9th CSPWG MEETING
Seoul, Republic of Korea, 13-16 November, 2012

Paper for Consideration by CSPCWG
Representation of fairway

Submitted by:	France (SHOM)
Executive Summary:	Representation of non regulated fairway
Related Documents:	S-4, B-432, B-434, B-434-5
Related Projects:	/

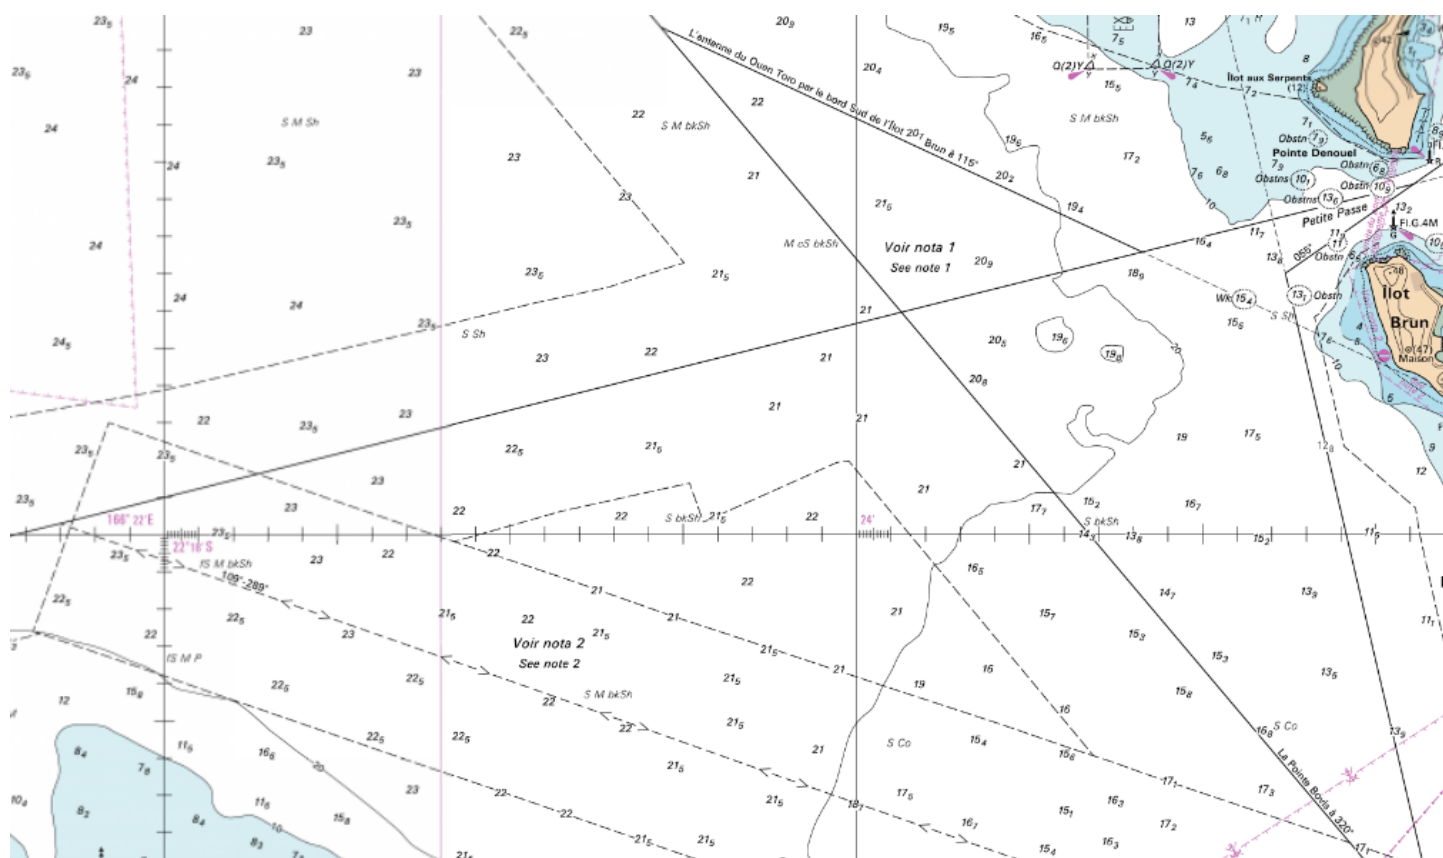
If we considered that all fairways are not designated by a regulatory authority, the magenta representation shown in B-434.5 is not adapted for non regulated fairways.

Considering that a fairway has specified outer limits (see B-434), France suggests that a non regulated fairway should be represented by a black limit using N1.1 symbol. This can be combined with a recommended track (M3 or M4) and a note to give details about the minimum depth, technical information about the survey...

France proposes to add an example in B-434.5 of non regulated fairway with a limit in black dashed line.

- a. endorse that a clarification is required for B-434.5 to explain how to represent non regulated fairway by a black dashed line.
